## **REMARKS**

## **AMENDMENTS TO THE DRAWINGS**

The attached sheets of drawings include replacement sheets for all drawings 1 through 7. In addition, annotated sheets of Figures 4B, 5 and 6 are provided to show the deleted reference numerals 468, 508, 514 and 604.

FIGURE 6

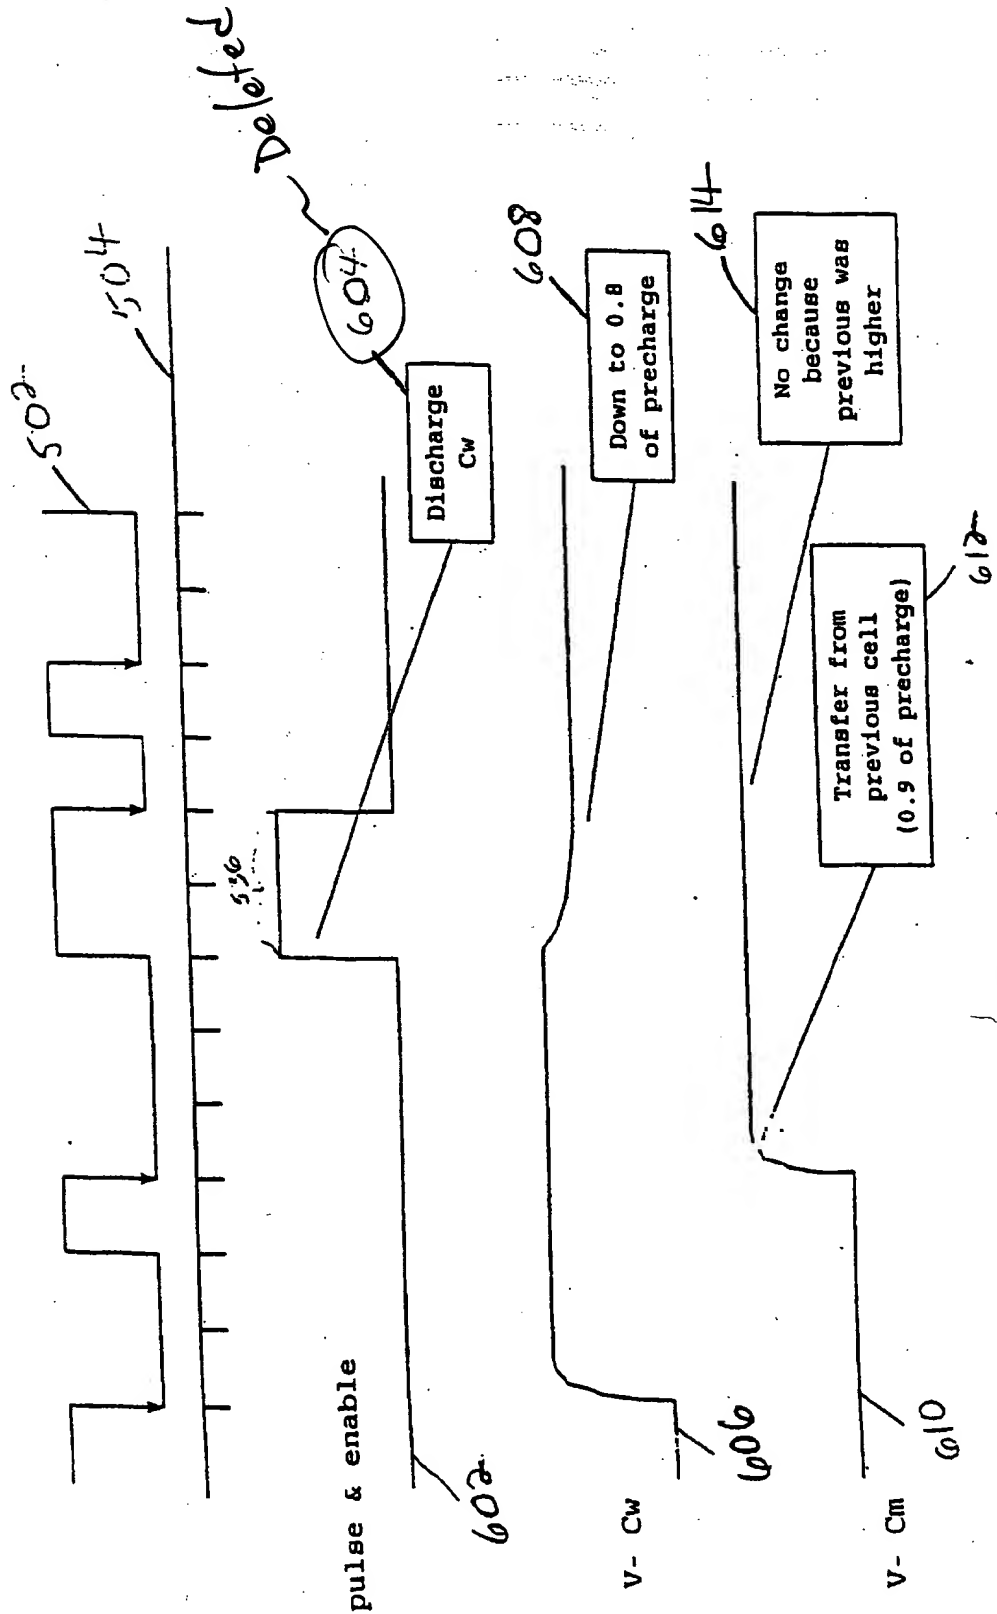
In regard to the objections to the drawings, replacement sheets are submitted herewith. (See Official Action dated 7/12/05, p. 2, ¶ 1) The replacement sheets have been corrected to omit reference numerals 468, 508, 514 and 604 since these numerals were not referenced in the original written description.
